HAWK 26 FED 709H

13. Describe Proposed or Completed Operation (clearly state all pertinent details, including estimated starting date of any proposed work and approximate duration thereof. If the proposal is to deepen directionally or recomple horizontally, give subsurface locations and measured and true vertical depths of all pertinent markers and zones. Attach the Bond under which the work will be performed or provide the Bond No. on file with BLM/BIA. Required subsequent reports shall be filed within 30 days following completion of the involved operations. If the operation results in a multiple completion or recomple in a new interval, a Form 3160-4 shall be filed once testing has been completed. Final Abandonment Notices shall be filed only after all requirements, including reclamation, have been completed, and the operator has determined that the site is ready for final inspection.)

**Hawk 26 Fed No. 709H
30-025-42402
EOG Resources, Inc
Surface Location: Sec. 26, T. 24S, R. 33E
Conditions of Approval**

Lea County, New Mexico
Proposed Wellbore
Revised 6/29/16
API: 30-025-42402

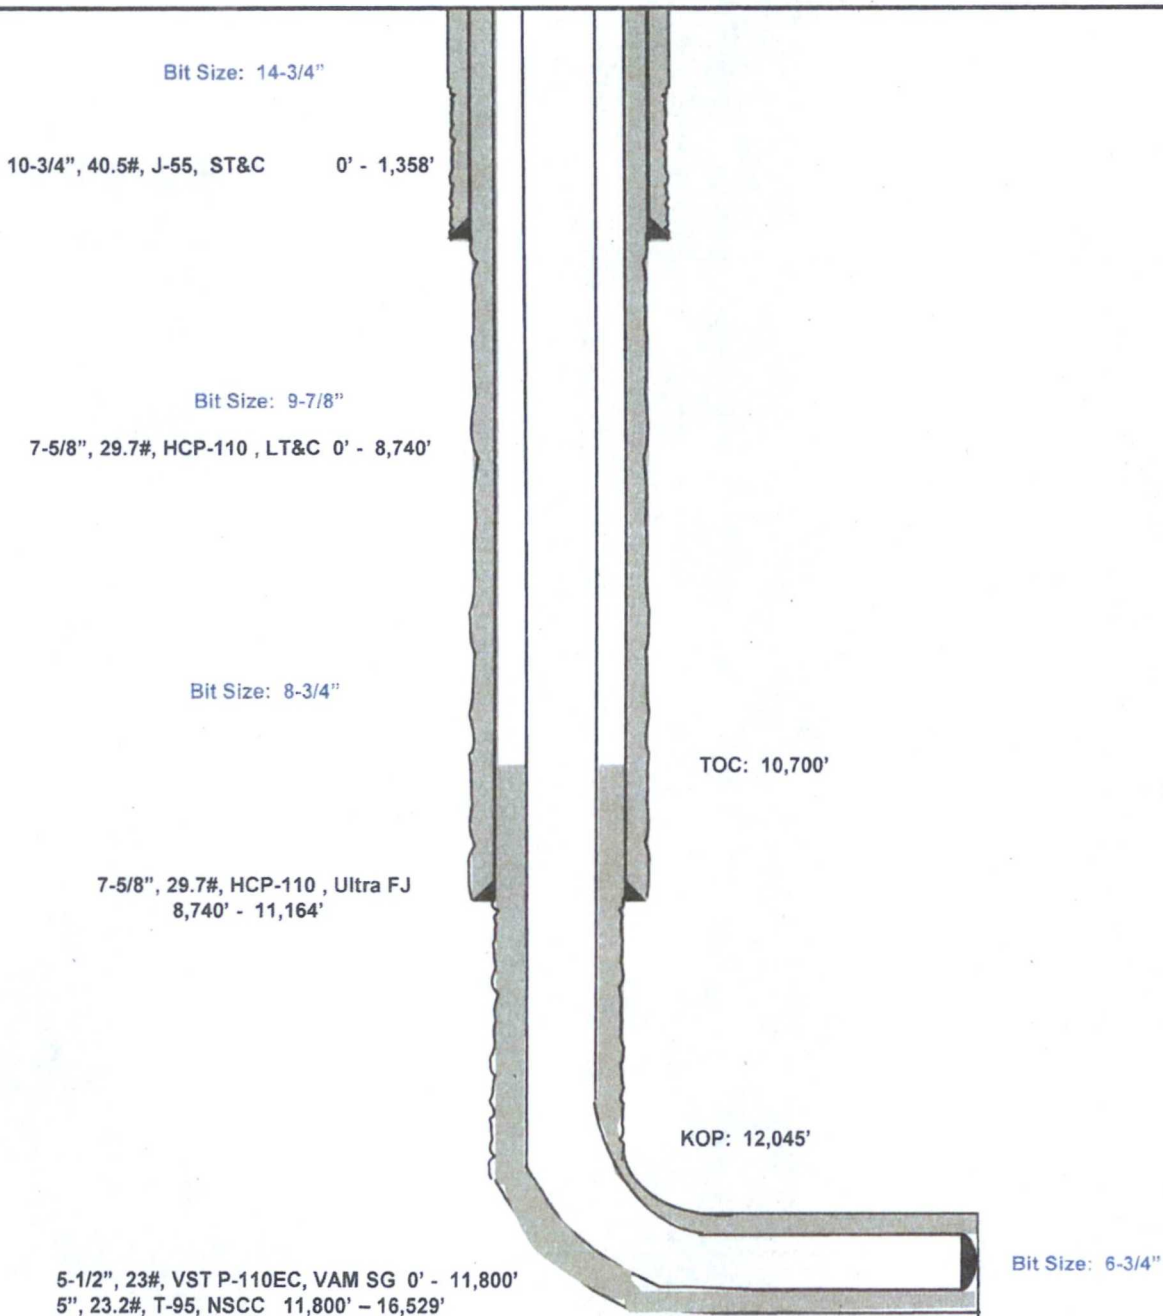
EOG Resources requests approval to run production casing on this well as follows:

5-1/2", 23.0# VST P-110EC VAM SG (0'-11800')

5", 23.2#, T-95 NSCC (11800'-16529' TD) w/ TAM Inflatable Packer at 16329' MD.

Cemented w/ 150 bbls + 25% excess Class H cement, 14.4 ppg, 1.20 CFS yield.
TOC estimated ~10700'.

A variance is also requested to wave any centralizer requirements.

Variance is granted for centralizers in the production interval per the drilling program.

1. The minimum required fill of cement behind the **5 1/2 X 5** inch production casing is:

☒ Cement should tie-back at least **500** feet into previous casing string. Operator shall provide method of verification.
